DATE May 20, 2026
FOR Telluride Public Works Transit Building Addition
Telluride, Colorado
EIDOS PROJECT NO. 23019

CONTRACTOR QUESTIONS

END OF ADDENDUM NO. 5

SPECIFICATION SHEET

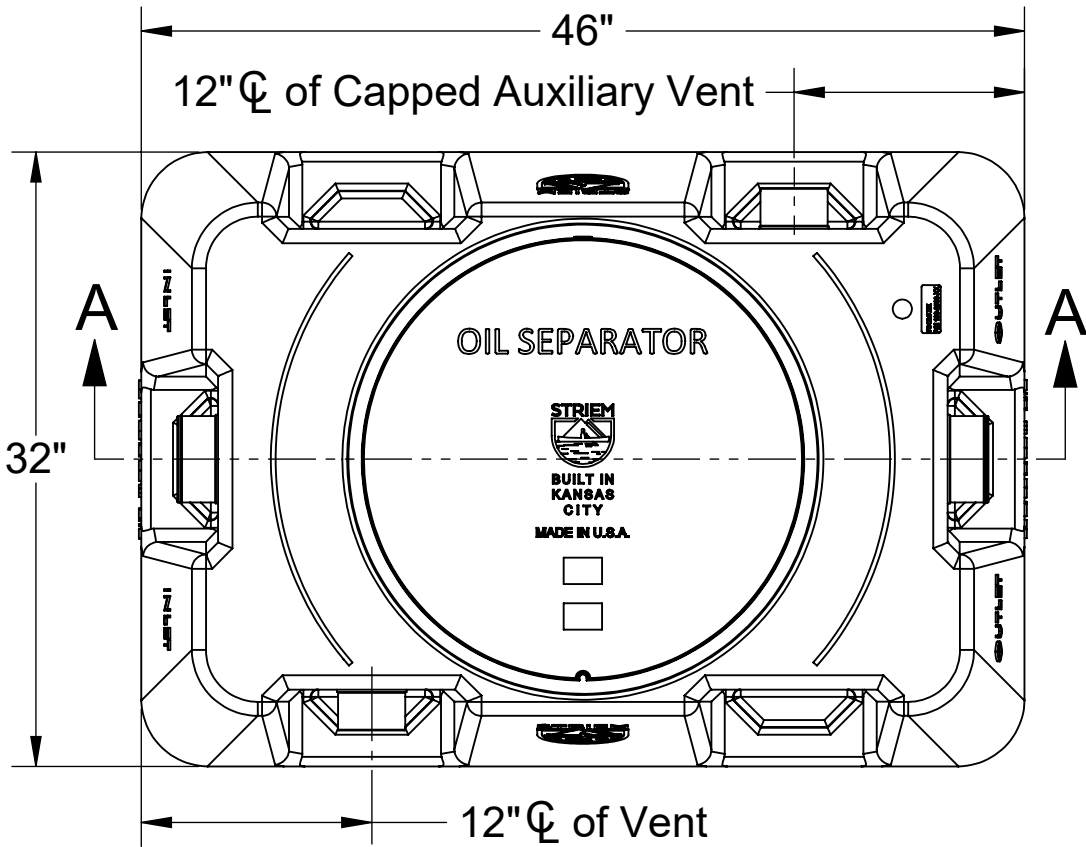
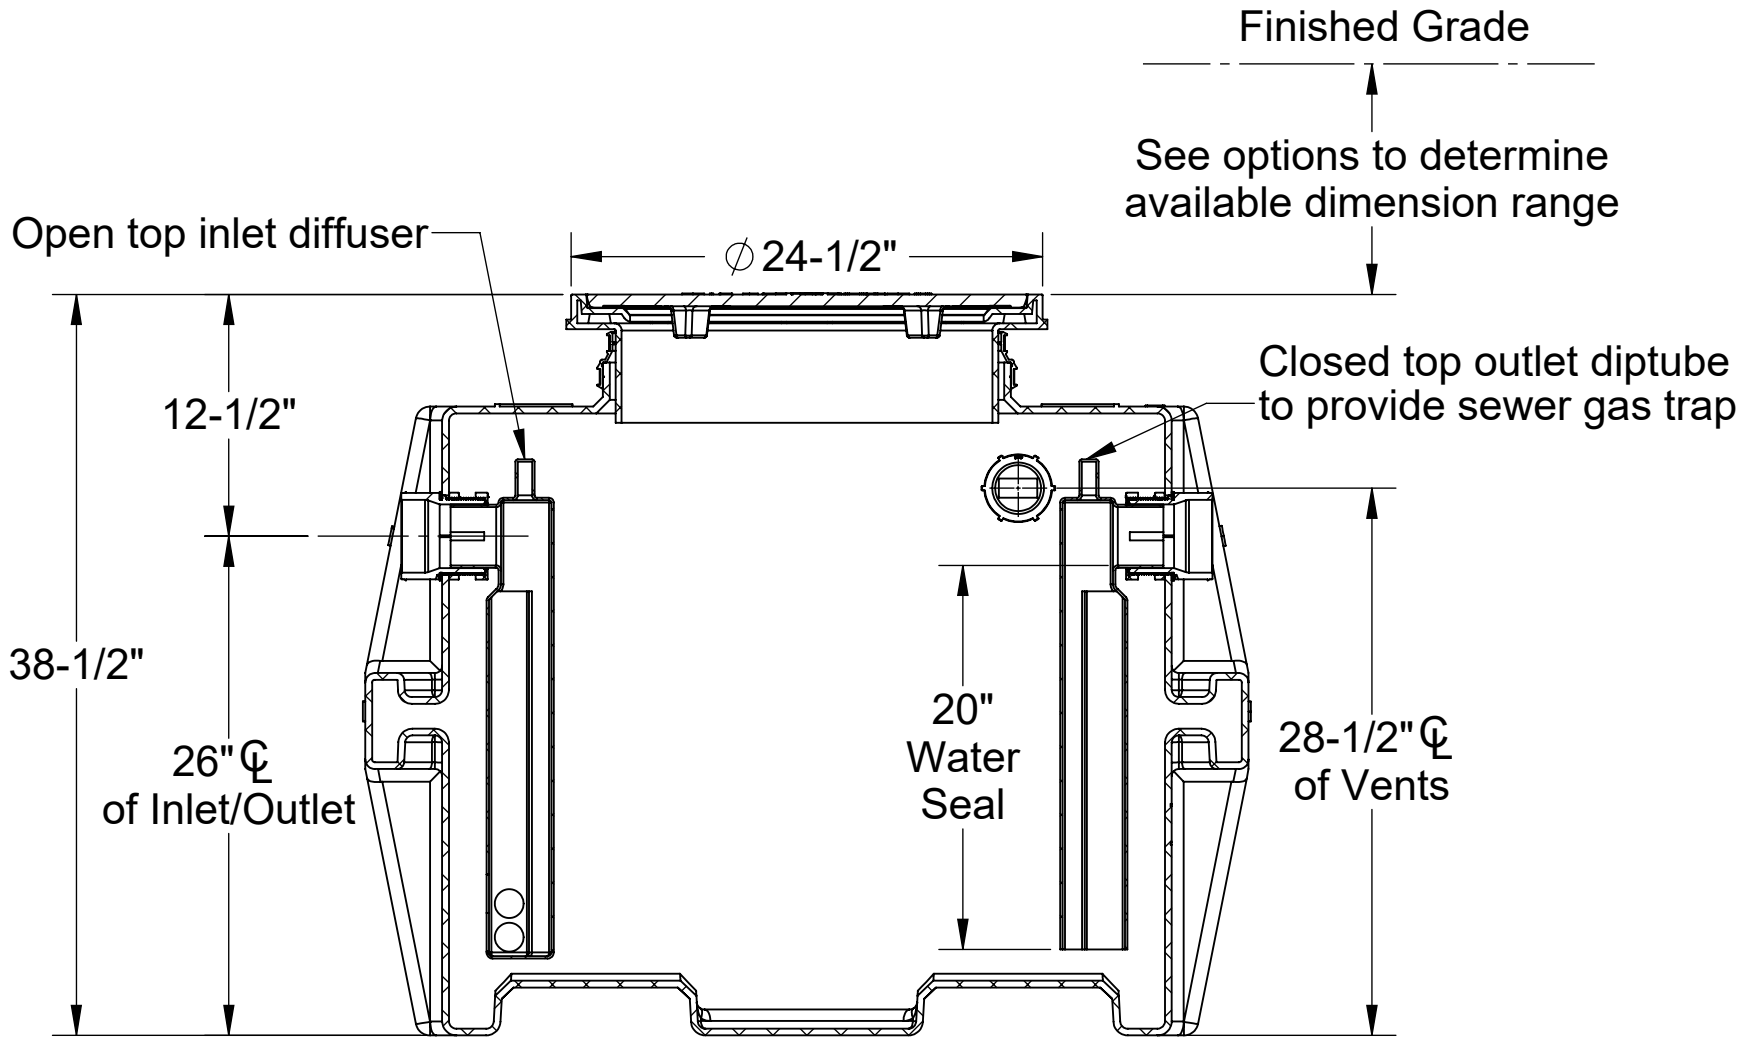
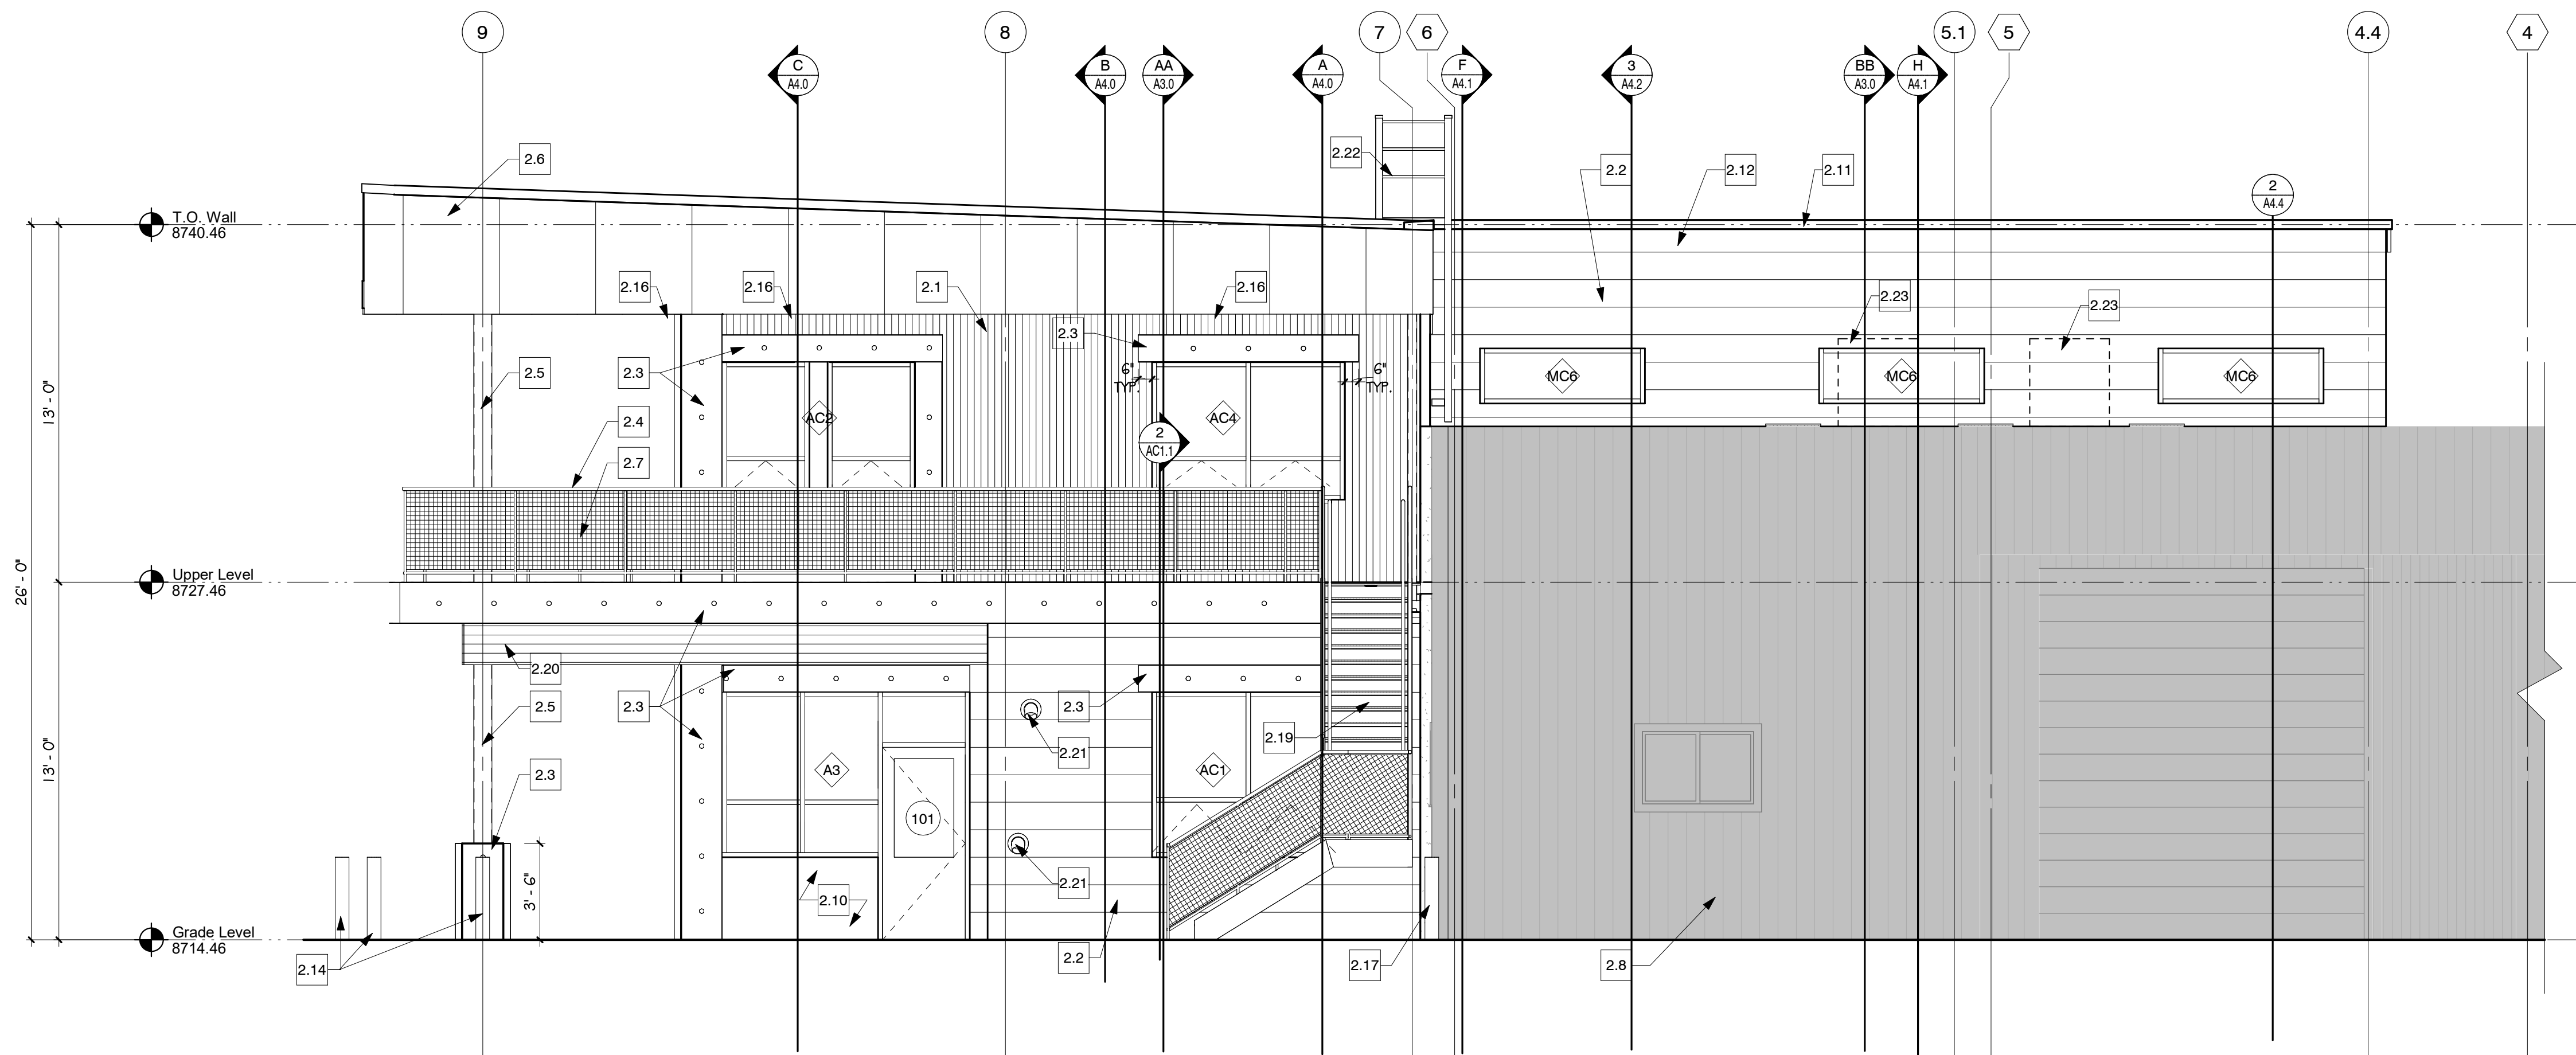
- Answer: **Provide tempered mirror per 2.2B to meet all safety requirements.**
17. On C3.0 – Horizontal Control Plan, the plan labels "OIL/WATER SEPARATOR (RE: PLUMB)" On the utility plan, the drawing gives some utility information: "46" x 32" OIL/WATER SEPARATOR (RE: PLUMB)," with 4" PVC connections, pipe slopes, invert elevations, and tie-in information to the existing sanitary sewer. We were unable to locate a plumbing schedule, detail, basis-of-design, capacity, model number, material requirement, traffic rating, lid/riser requirements, venting/cleanout requirements, or whether the existing separator is to be removed/disposed of or abandoned. Please provide the requirements for this unit.

- Answer: **Mechanical Response: Based on coordination meetings between civil and plumbing it is anticipated the new interceptor will be a Striem, 75 GPM, 4"Ø, polyethylene tank type interceptor equivalent to Striem OS-75 model. The interceptor shall be provided with dual (2) cleanouts upstream/downstream of interceptor with 3"Ø vent connections between closest cleanout and interceptor, slick stick oil level monitoring system, the storage chamber will be vented per manufacturer's installation instructions, lid will be AASHTO H-20 traffic rated lid, provide lid extensions as necessary for lid to be flush with grade, if necessary confirm if high water table hold down kit will be required with civil engineer prior to ordering. See attached cut sheet for example.**

Sheet Title:
Door & Frame
Types, HJS Details

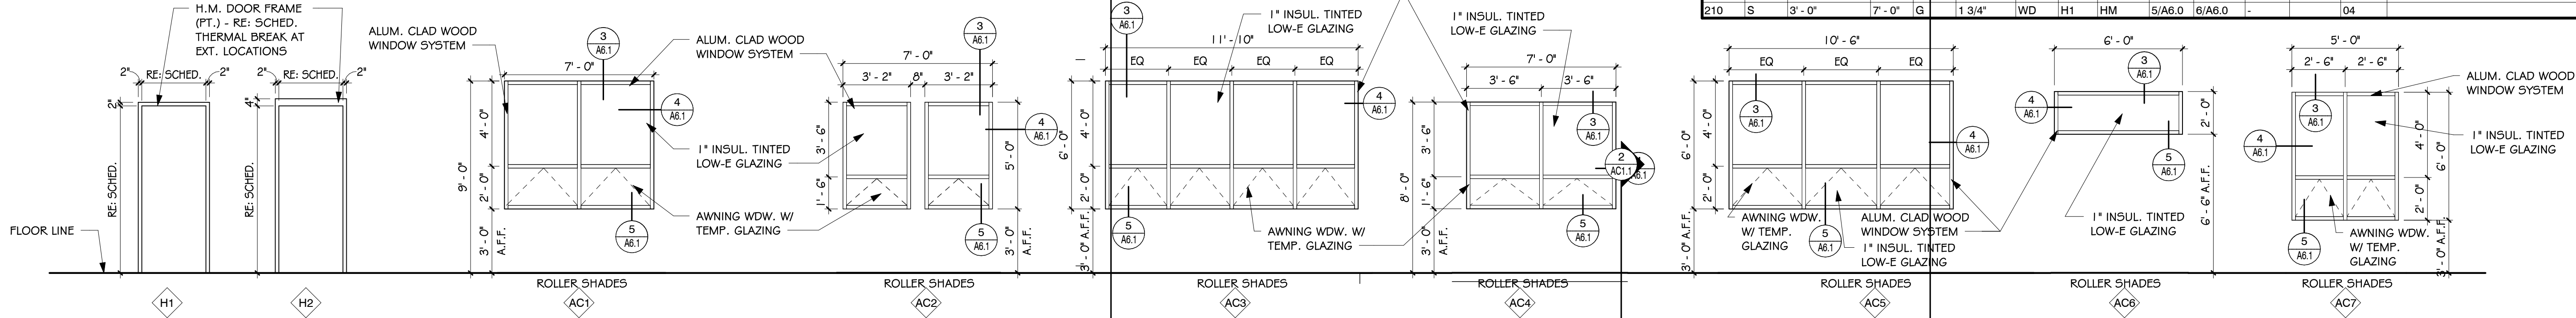
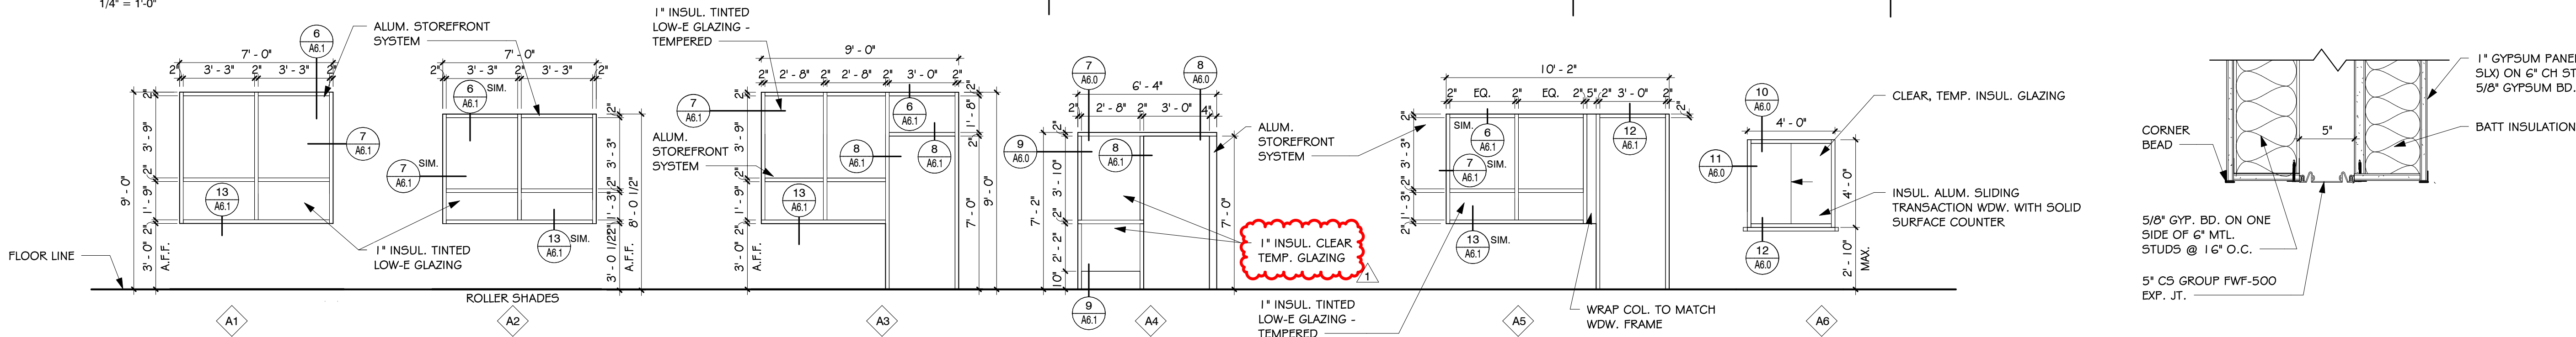
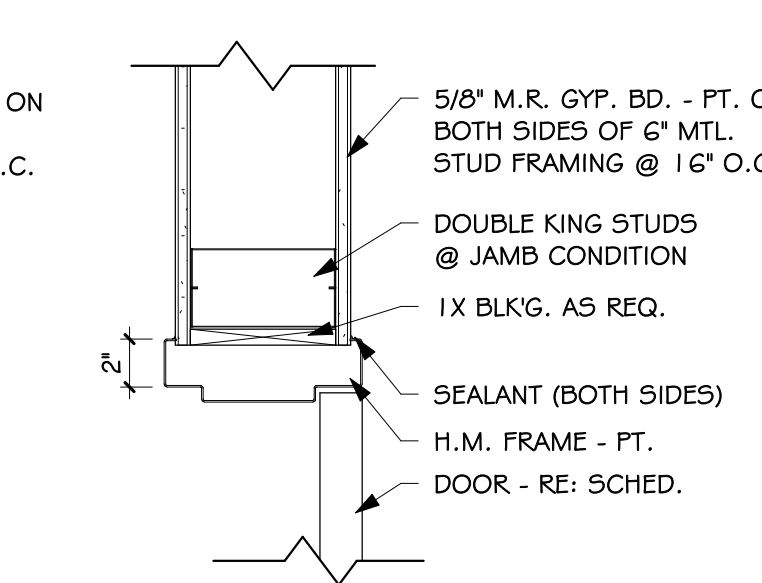
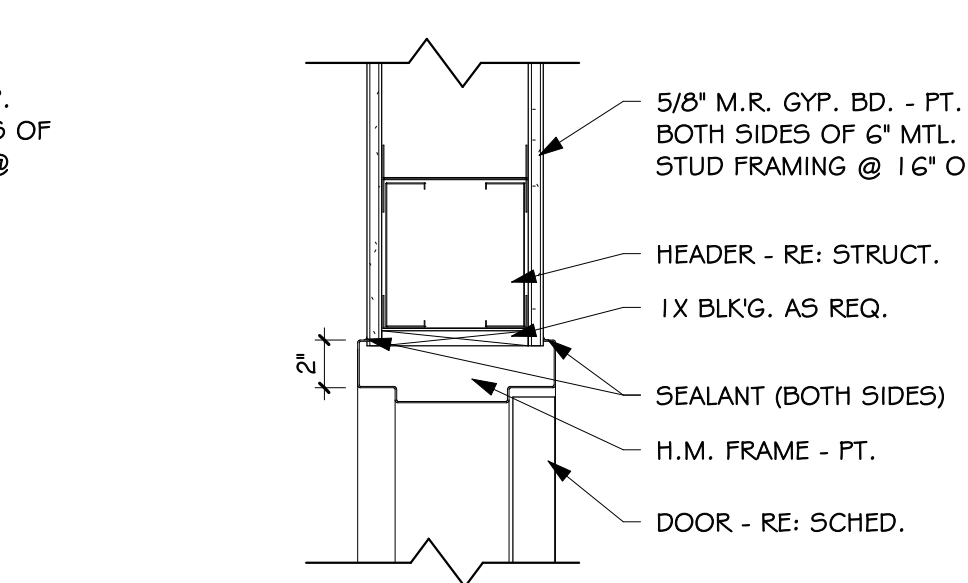
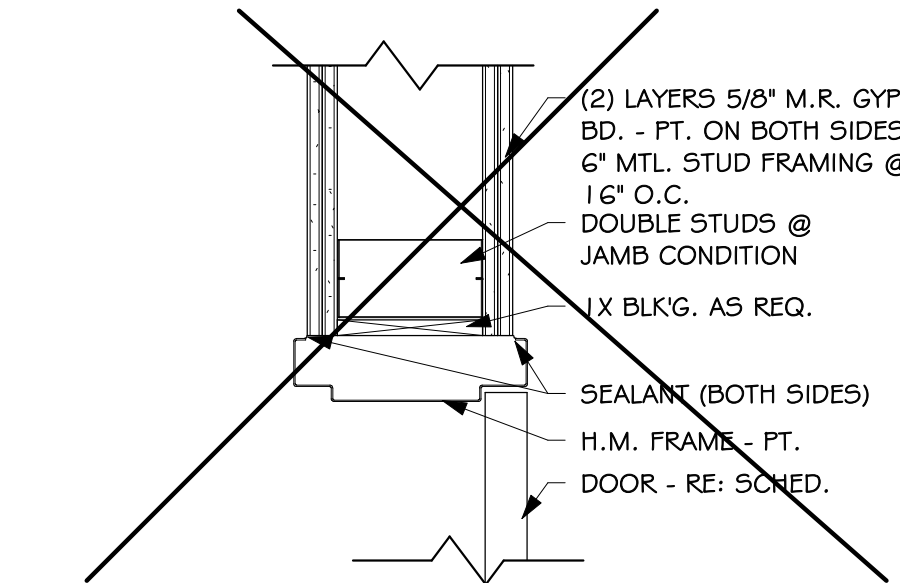
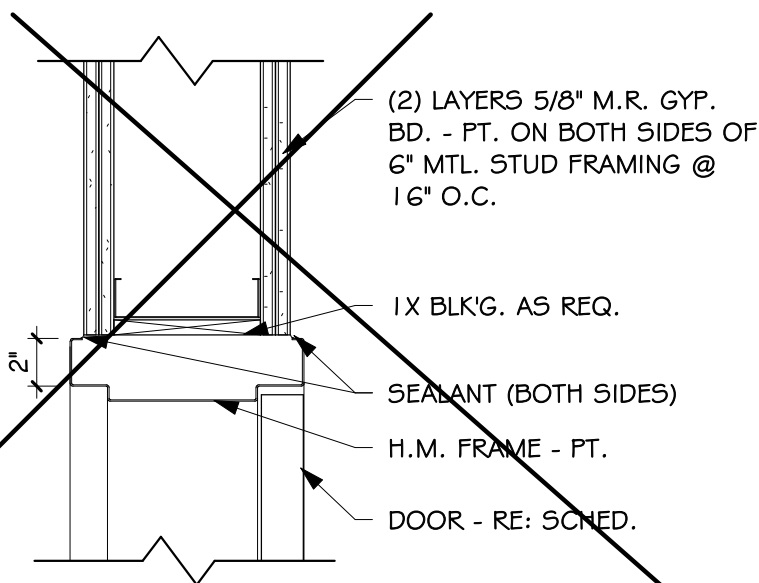
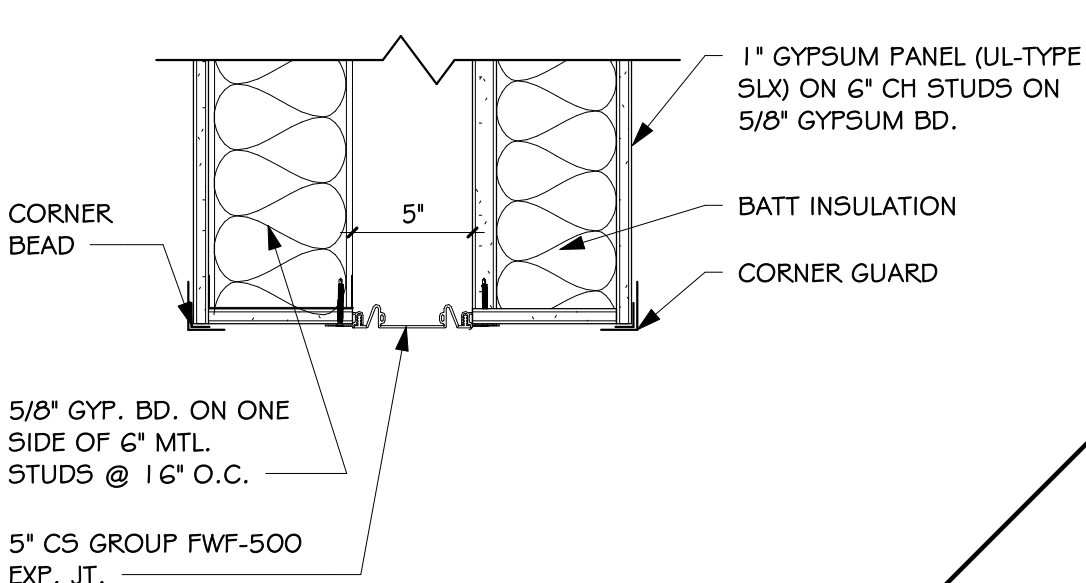
- Answer: **Windows shall be center set glazing.**
14. The schedule on A6.0 lists a door type "N" for door 106b that is not shown in the legend. Does this require glazing?

- Answer: **See revision to door 106B on Sheet A6.0 on the Door and Frame Schedule.**
15. Interior SF Door 102 and Frame A-4 have a call out for insulated low-e glass. Should this be clear insulated glass or 1/4" glazing?

- Answer: **Provide 1" clear glazing for SF Door 102 and Frame A-4. See revised sheet A6.0.**
16. 08 8300 2.2 B specifies tempered mirror and 2.2D specifies safety backing. These items are not typically specified together. Are both required or can either be used to meet safety requirements?
